1. **Site Address:** Crowndale House, Crowndale Road, Camden, London, NW1 1TP
2. **Project:** Cladding remediation to existing 6 storey block of flats
3. **Inspection Date:** 17/01/2025
4. **Weather:** Overcast
5. **Inspection Number:** 01
6. **Site Contact:** Ben Lockerby (GPF Lewis) – 07840 838 438
7. **Inspection Type:** External Wall Survey

8. Overview

9. Summary

Item: 1

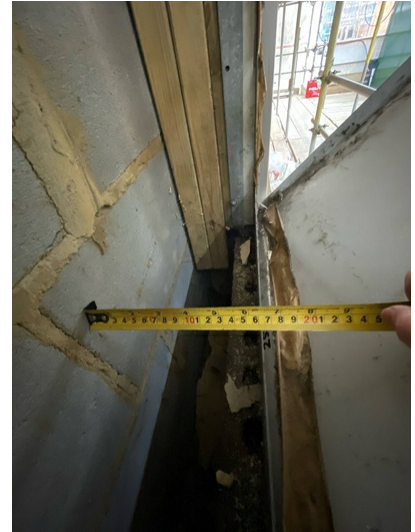
Comment: Opening made by removal of aluminium cladding panel revealing approx. 170mm cavity/void with blockwork inner skin. 2No. timber battens (~45mm thick) in place vertically to window jambs. Site agents advised that windows are fixed through to the timber battens, therefore it has been requested these remain in place - Agreed for timber battens to remain as the proposal is to close the area off with a form of cavity barrier (possibly 12mm cementitious board). Advised horizontal cavity barriers will also be required at the top and bottom to close the edge of the cavity (masonry inner leaf will require some remediation).

Item: 3

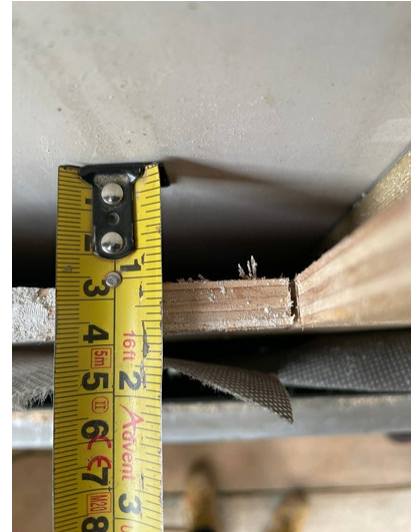
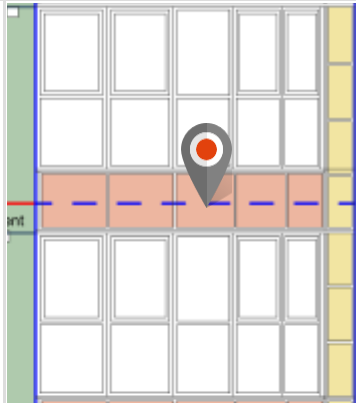
Comment: Opening made through the cladding showing 9mm plywood with breather membrane over. Vertical steel in place with partial fill mineral wool insulation within the web. 12mm white board (unknown product) present over the outer face of the steel (which has been cut to reveal internal build-up). Noted that void behind the white board appears to be free of insulation or vertical cavity barrier to the party wall line. White board also does not return down the steelwork.

Discussed fire protection to steelwork within the cavity. Advised that the exposed face of the steels should be provided, however received further comments from Building Control after the site visit that advised any steelwork (primary structure) should be provided with fire protection as this would be classed as a defect.

Fire protection to the steel structure is to be confirmed. Proposed details indicate partial fill mineral wool insulation to be installed (to replace all existing insulation), along with cavity barriers being installed to compartment wall/floor lines and around openings.

Item: 4

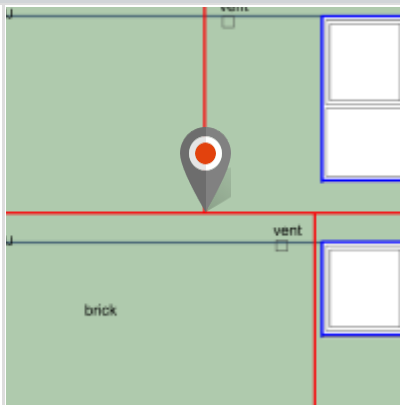
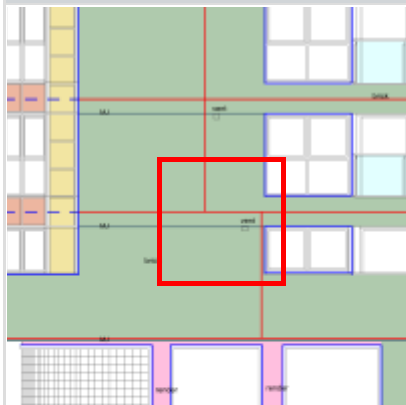
Comment: Cladding panel removed along the compartment floor line. Build-up appears to include grey breather membrane over 18mm plywood with approx. 140mm void behind. Partial fill mineral wool insulation present within the void sporadically located. No cavity barriers could be seen along the compartment floor zone or at the edges of the cavity/above or below the curtain walling system. Steelwork within the void also does not appear to have been provided with any fire protection within the cavity.

Fire protection to the steel structure is to be confirmed. Proposed details indicate partial fill mineral wool insulation to be installed (to replace all existing insulation), along with cavity barriers being installed to the compartment floor.

Item: 5

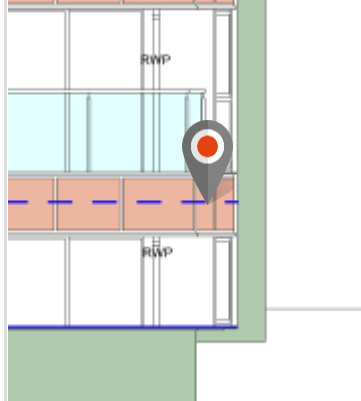
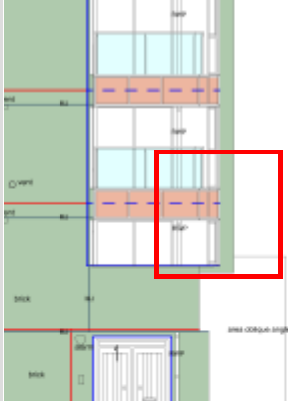
Comment: Opening made through the removal of bricks revealing approx. 110mm cavity and a blockwork inner leaf. Steel I beam present horizontally across the top of the blockwork, with what appears to be a steel windpost present vertically. Neither steel appears to have any fire protection within the cavity, therefore presume suitable protection has been provided from the inside. Insulation within the cavity appears to be a mixture of partial fill mineral wool and PIR/Phenolic insulation.

No cavity barriers were visible to the compartment floor zone, however it is unclear whether the design of the masonry wall is in accordance with the recommendations of ADB diagram 8.2.

Fire protection to the steel structure is to be confirmed. Proposed details indicate partial fill mineral wool insulation to be installed (to replace all existing insulation), along with cavity barriers being installed to compartment wall/floor lines and around openings.

Item: 6

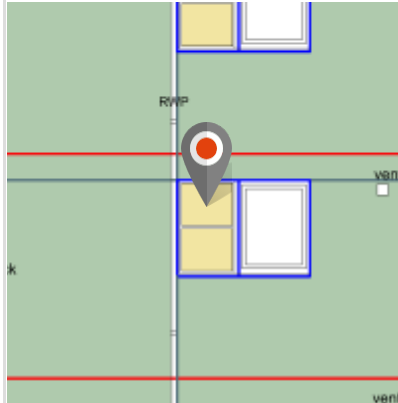
Comment: Cladding panel removed along the compartment floor line. Build-up appears to include grey breather membrane over 18mm plywood with approx. 160mm void behind. Partial fill mineral wool insulation present within the void sporadically located. No cavity barriers could be seen within the void. Steelwork within the void also does not appear to have been provided with any fire protection within the cavity.

Vertical closed state cavity barrier at the edge of the building to separate the balcony.

Horizontal open state cavity barrier required at compartment floor level.

Cavity barriers required vertically and within the cladding at the edge of the building line and horizontally to the compartment floor location between the windows. Balcony structure would not strictly require fire protection due to being external and is not classed as a compartment floor. Recommend this is reviewed with Building Control to confirm acceptability.

Recommend further opening up works are undertaken to assess full as-built scenario.

Item: 7

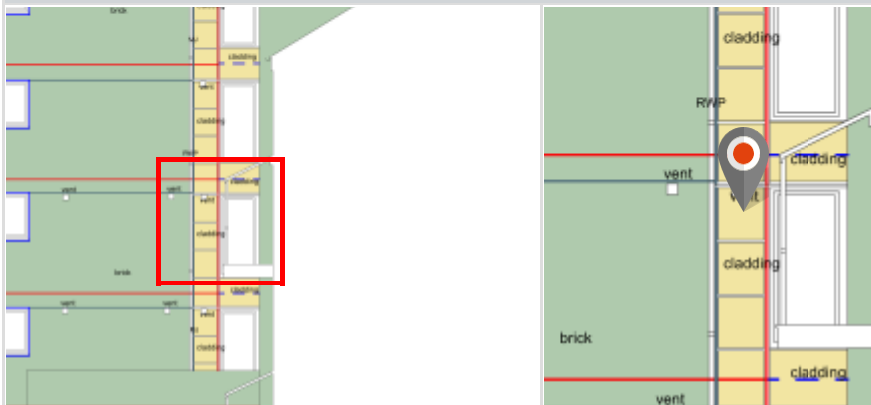
Comment: Opening made by the removal of 1x aluminium cladding panel revealing a grey breather membrane, approx. 190-200mm void, partial fill mineral wool and 100mm PIR insulation, ~12mm plywood and a blockwork inner skin. No cavity barriers could be seen at the edges of the cavity or around the window opening.

Recommend combustible insulation and plywood is removed and replaced with suitable alternatives that achieve a minimum classification to fire of Class A2-s1, d0 when tested in accordance with BS EN 13501-1. Cavity barriers are also to be installed around the window opening as per the proposed design.

Item: 8

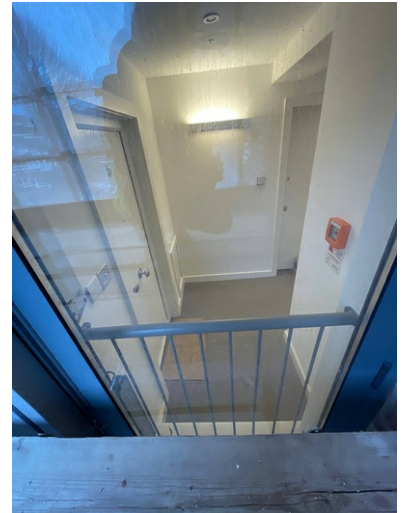
Comment: Opening made by removal of an aluminium cladding panel revealing an empty void with steelwork and electrical cables present. Brickwork inner leaf present. No vertical compartmentation appears to be present between the corridor and the flat within the wall and likewise, no horizontal cavity barrier appears to be present to the slab level behind the cladding.

Phenolic/PIR insulation appears to be present behind the adjacent brickwork outer leaf.

Fire protection to the steel structure is to be confirmed. Proposed details indicate partial fill mineral wool insulation to be installed (to replace all existing insulation), along with cavity barriers being installed to compartment wall/floor lines and around openings.

Item: 9

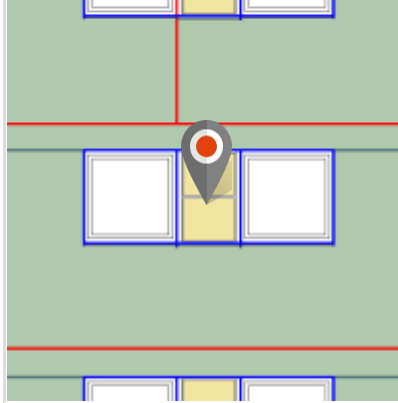
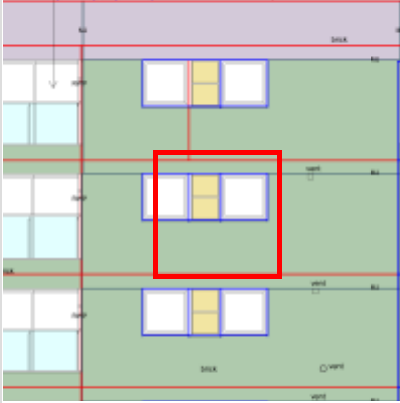
Comment: Opening provided by removal of aluminium cladding panel revealing partial fill mineral wool/PIR insulation and blockwork inner leaf. Edges of the window frames appear to be present exposed within the cavity with no closer or cavity barriers present around the window.

Window frames can be seen. No fire protection or weather protection. Pir insulation present

Fire protection to the steel structure is to be confirmed. Proposed details indicate partial fill mineral wool insulation to be installed (to replace all existing insulation), along with cavity barriers being installed to compartment wall/floor lines and around openings.

EAST ELEVATION

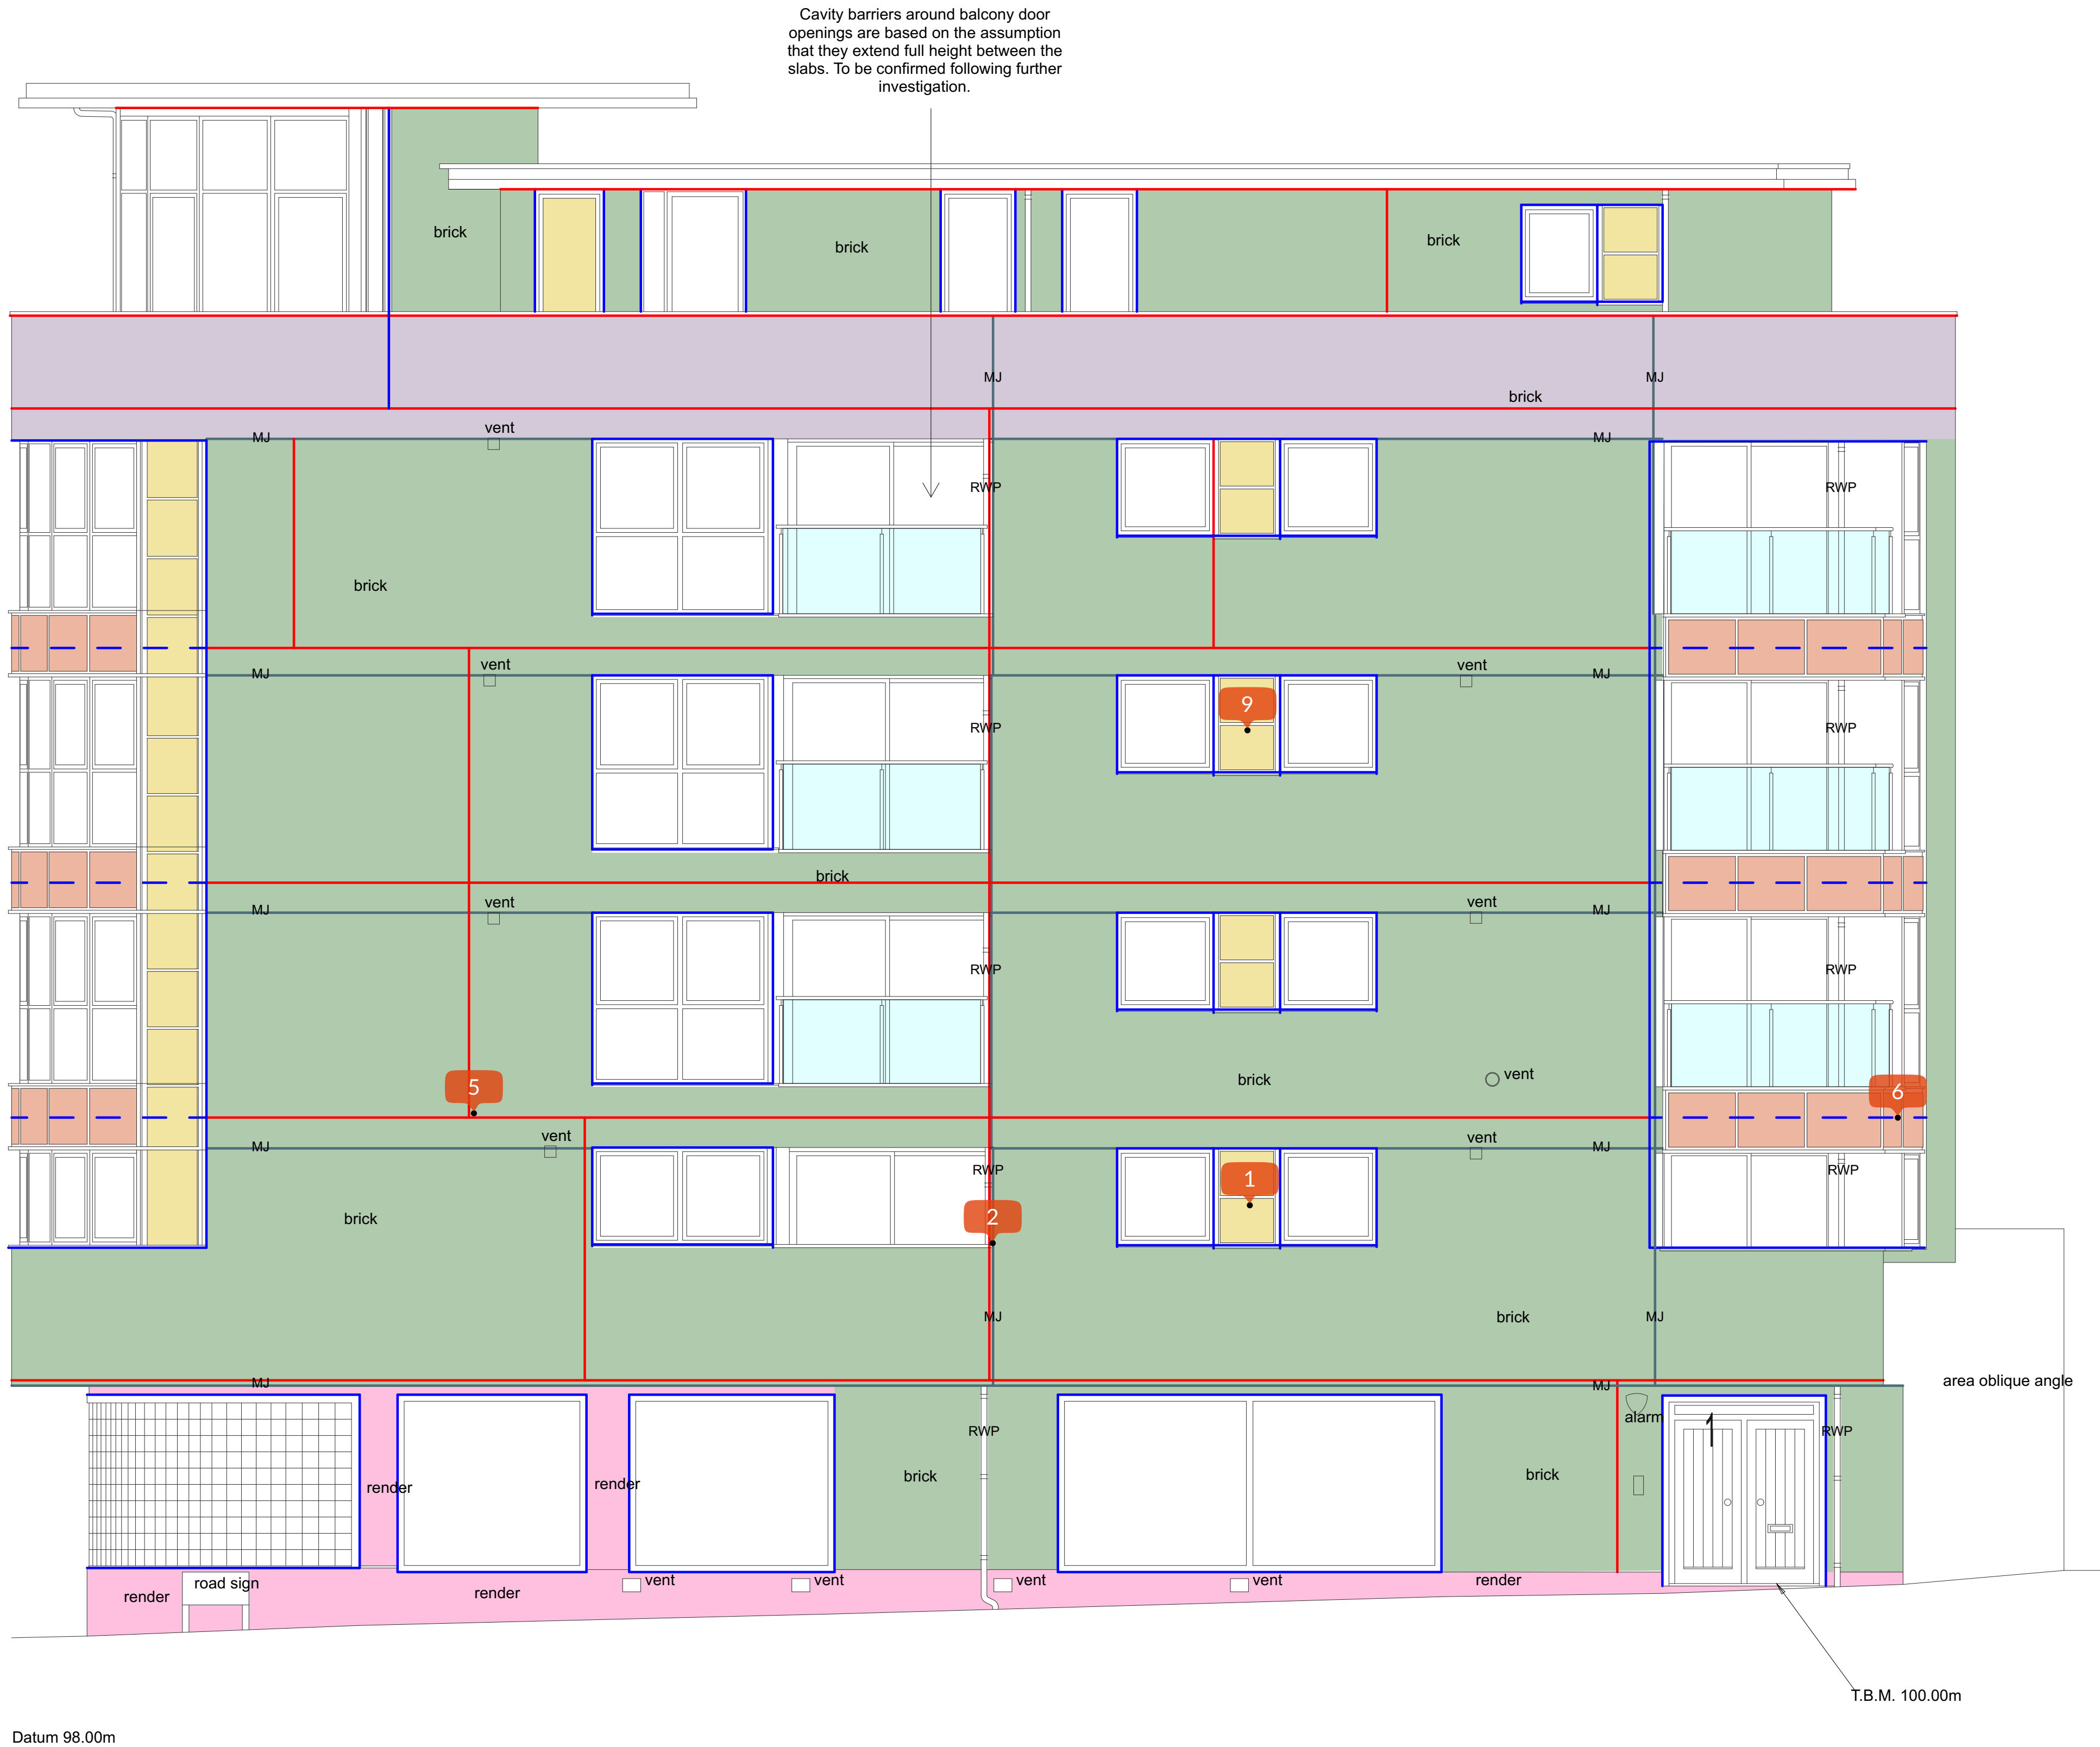
PLEASE NOTE:
THESE ARE **NOT** AS BUILT DRAWINGS. ALL
DISCREPANCIES ARE DUE TO "AS BUILT" INFORMATION
AVAILABLE - NEEDS FURTHER CONFIRMATION
